RE: Full planning permission is being sought for the following development:

Your Ref: SD22A/0045

Client: Pavement Homes Ltd.

FURTHER INFORMATION RESPONSE

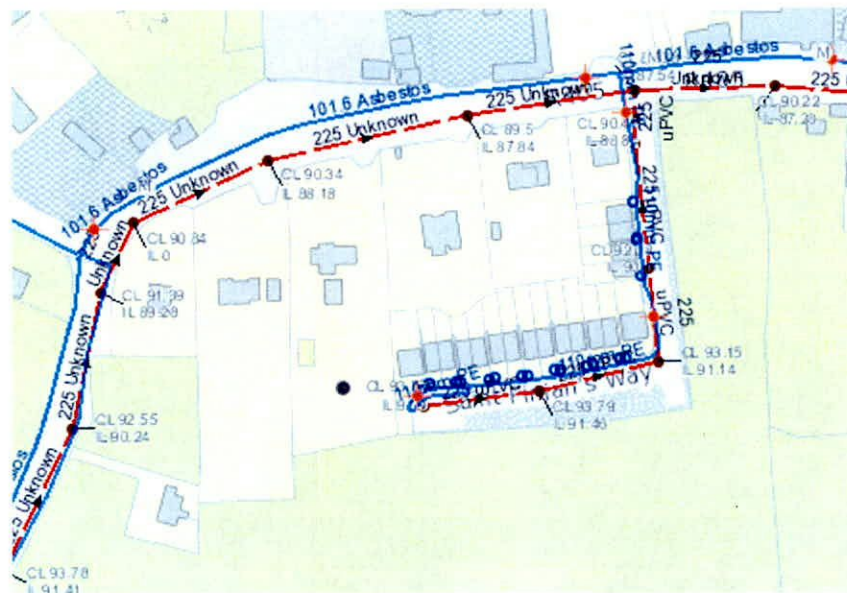
6. (i) There is no watermain drawing submitted. The applicant is requested to submit a drawing showing the watermain layout of proposed development. The applicant is requested to submit a drawing showing the distance between proposed development and existing 6" watermain south of same.
- (ii) The applicant is requested to obtain a confirmation of feasibility letter (water and foul) from Irish Water and submit same to Water Services Planning Authority South Dublin County Council.

A watermain was clearly denoted on the original submission and is also denoted on the site services drawing included with this response. We have submitted a pre-connection enquiry to Irish Water regarding the proposed development and await their response, reference number CDS22006273. I have spoken to the area engineer who has confirmed no issues with capacity to serve this development of 6 units.

In our discussion we have spoken to Irish Water about a possible 6" watermain located to the south of the development and they have no record of such main existing. They provided the extract below denoting all of their services in the area.

Original approved landscape plan.

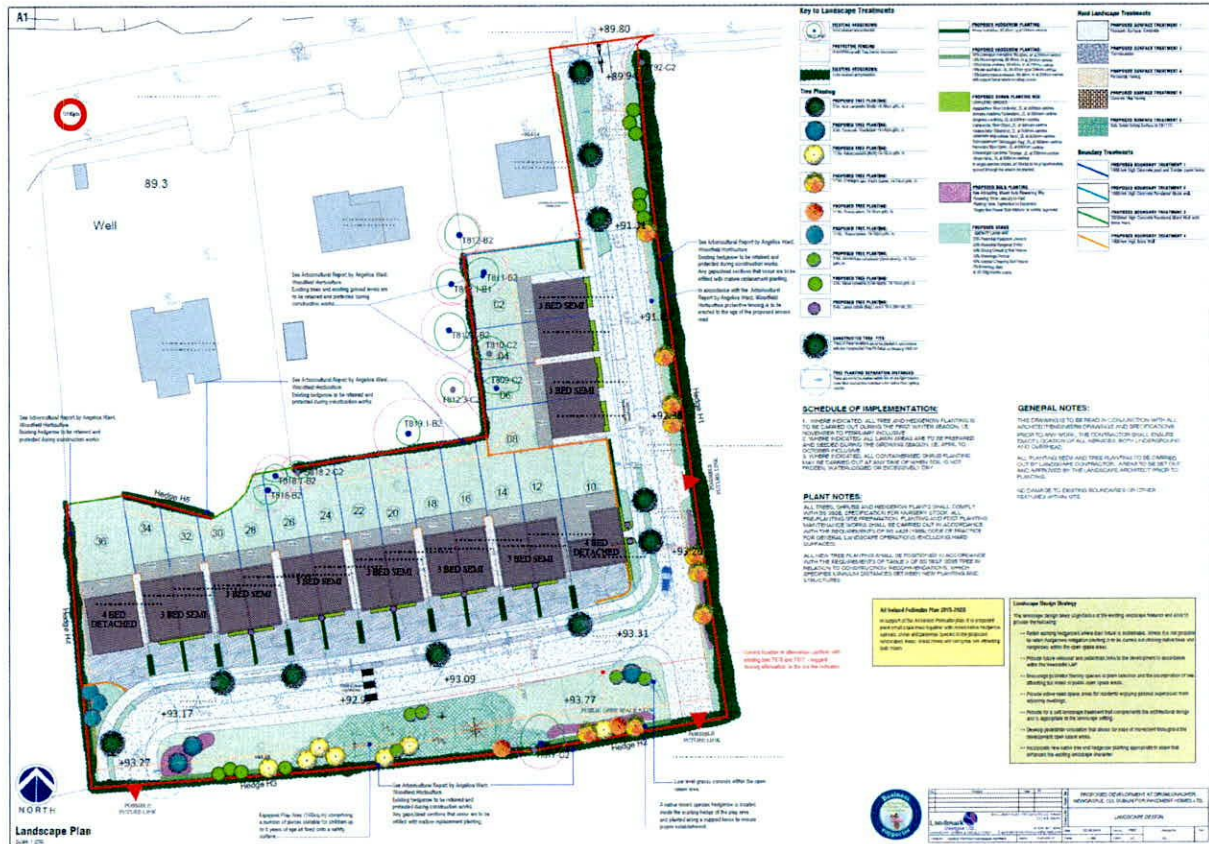
- Public Realm are concerned at the lack of street trees provided along most of the streets in this development. Street trees should be provided fully in Public Areas and not between private or management company driveways. Street Tree Planting should be located within the Public Realm and include SUDS features. The applicant is requested to submit revised proposals in this regard. Response should include additional street trees within the Public Realm.

The trees provided along the streets are in accordance with the previously approved land landscape plan. The green area to the south is not completed yet and will be completed once the adjoining development is completed. Due to the restrictions on site, i.e. vehicular access to dwellings, may we propose that we meet with the Park Department so that locations for the additional trees can be agreed. We are happy that this could be a 'prior to commencement' condition if planning is approved at this location. Please see aerial image below of the existing development and also a snip of the original approved landscape plan.

In addition to the above great efforts have been made to retain the existing mature boundaries and burgages, as evident above which creates a scenic enclosed development within a mature setting. It is our intention that this will be implemented in the proposed development which will ensure continuity between the two developments.
